Figure 7B-1. Signs in School Areas and at School Crossings (Sheet 1 of 2)

Summary of Comments on CAMUTCD 2026 7B Fig.pdf

Summary of Comments on Part 7B Figure CA MUTCD 2026

Figure 7B-4. Example of Signing for a School Zone with a School Speed Limit and Higher Fines Only for Speeding

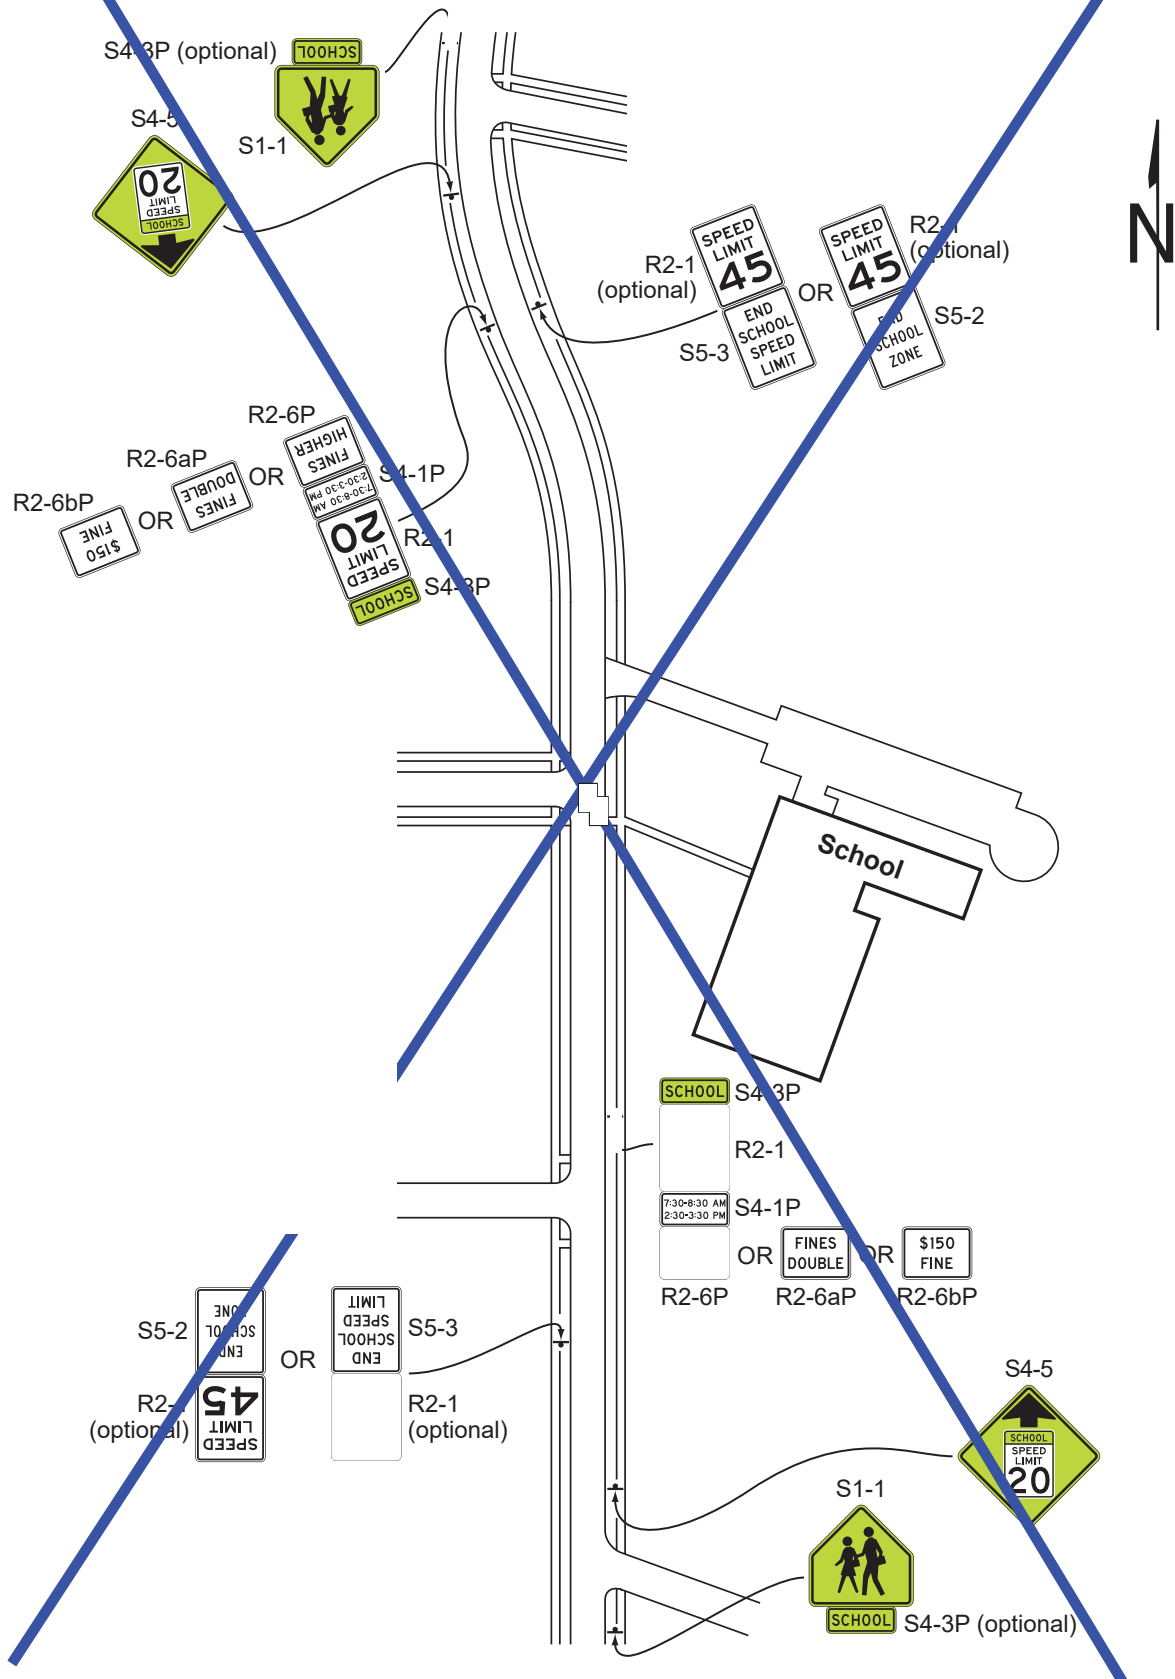
Number: 3 Author: s116730 Subject: Highlight Date: 7/25/2024 9:50:21 AM
NMUTCD 2023 changed NMUTCD 2009 Figure number 7B-3 to 7B-4 and made other minor changes in the figure. This figure was shown in CA MUTCD 2014R8 with a blue "X".NMUTCD 2023 Figure 7B-4 is shown in CA MUTCD 2026 with a blue "X"

Figure 7B-5. Example of Signing for a School Zone with Higher Fines for All Traffic Violations (Sheet 1 of 2)

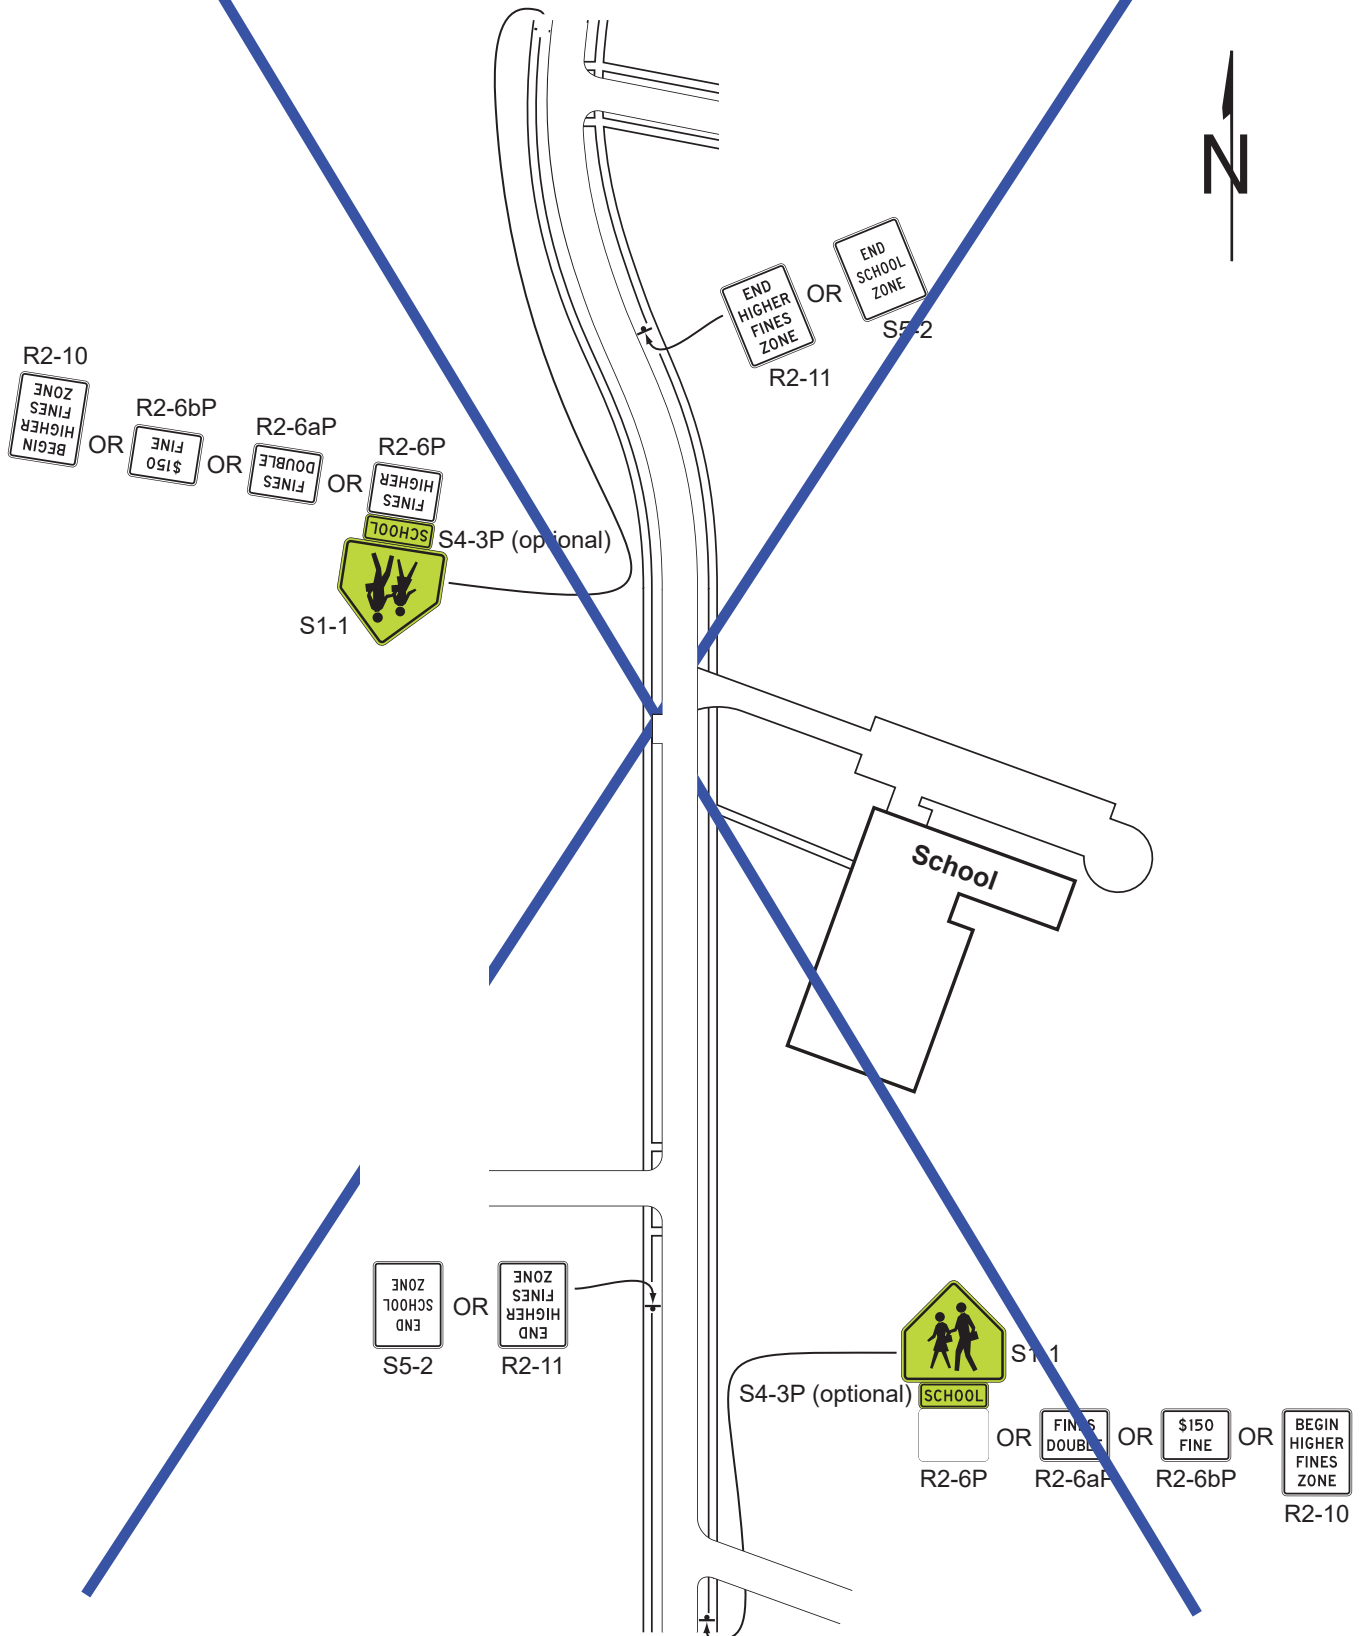
Number: 3 Author: s116730 Subject: Highlight Date: 7/25/2024 9:50:27 AM
NMUTCD 2023 changed NMUTCD 2009 Figure number 7B-2 to 7B-5 (Sheets 1 and 2 of 2) and made other minor changes in the figure.
NMUTCD 2023 Figure 7B-5(Sheet 1 of 2) is shown in CA MUTCD 2026 with a blue "X"

Figure 7B-5. Example of Signing for a School Zone with Higher Fines for All Traffic Violations (Sheet 2 of 2)

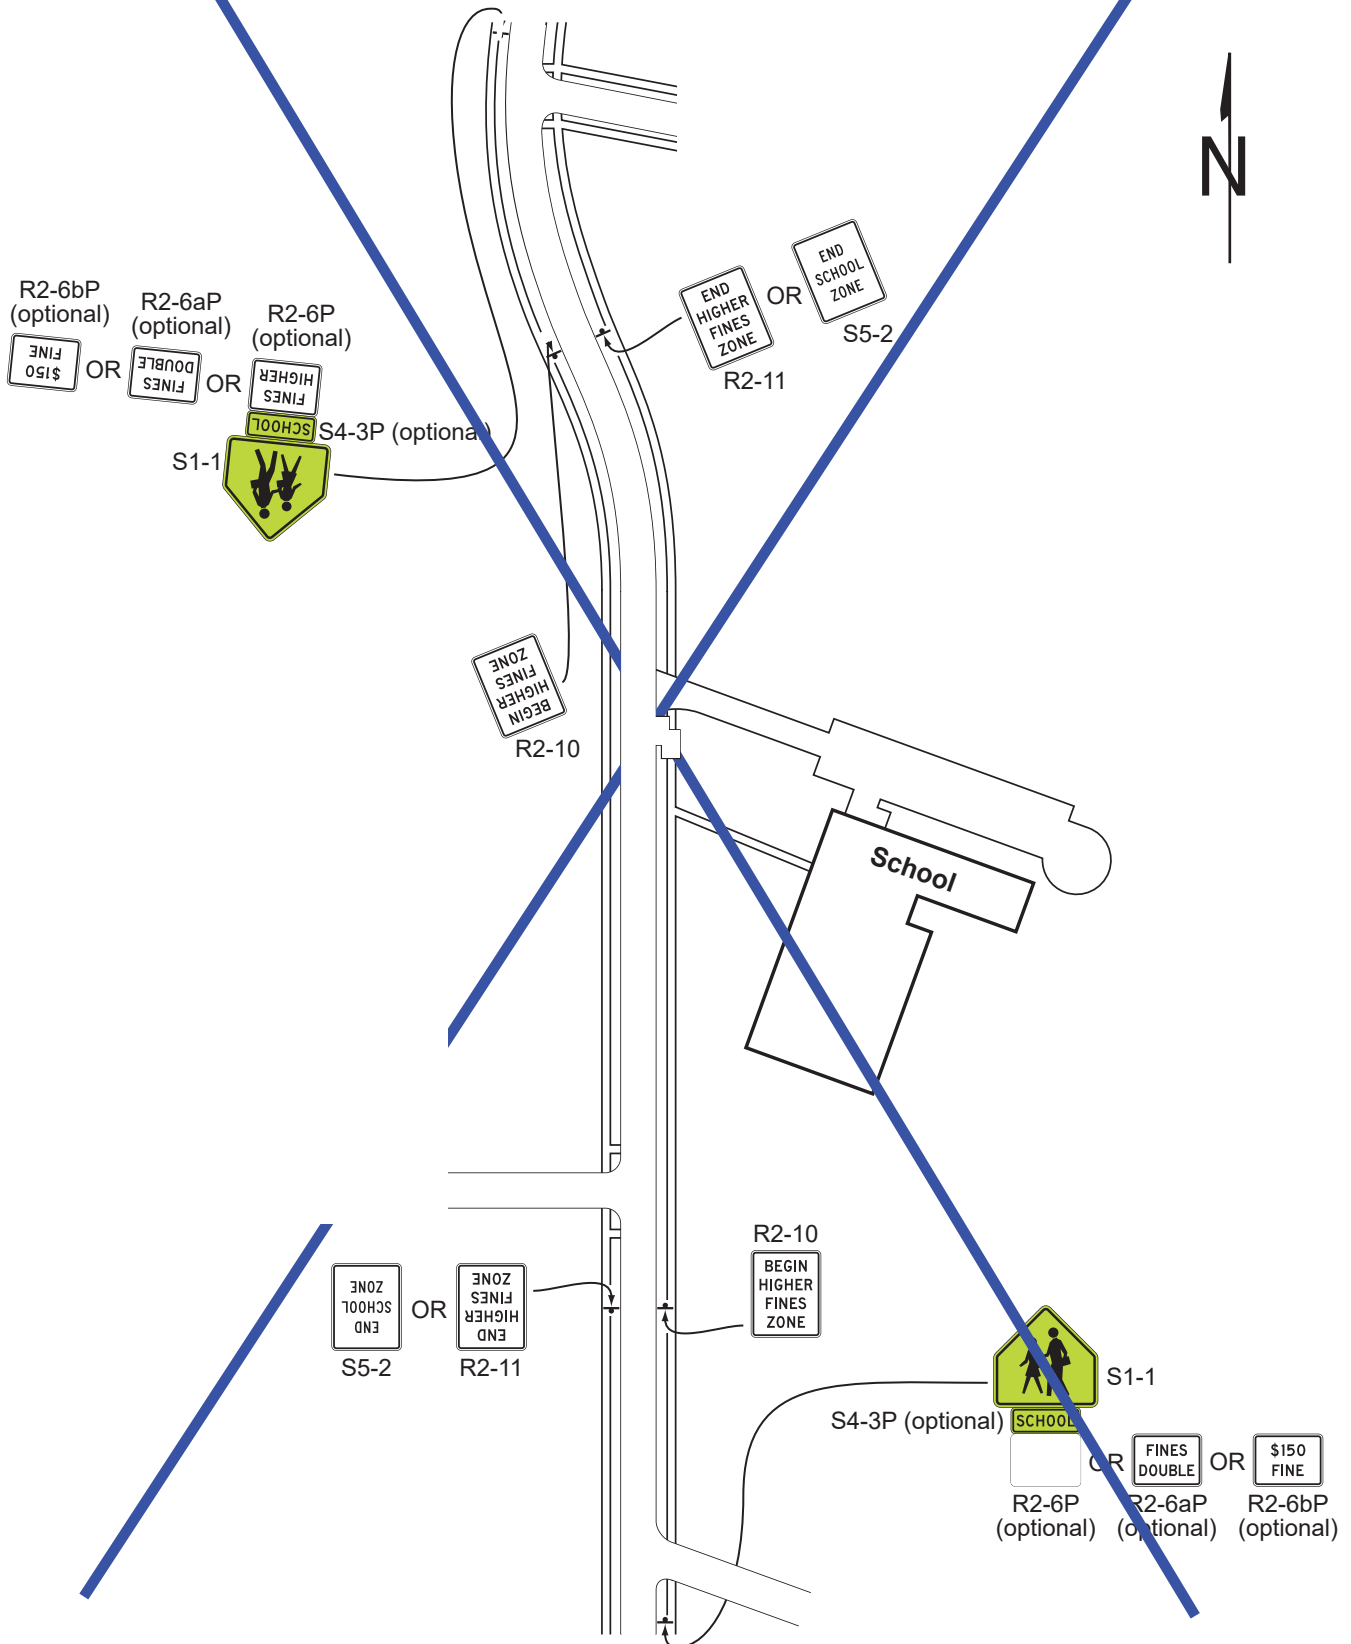
NMUTCD 2023 changed NMUTCD 2009 Figure number 7B-2 to 7B-5 (Sheet 1 and 2 of 2) and made other minor changes in the figure.
NMUTCD 2023 Figure 7B-5(Sheet 2 of 2) is shown in CA MUTCD 2026 with a blue "X"
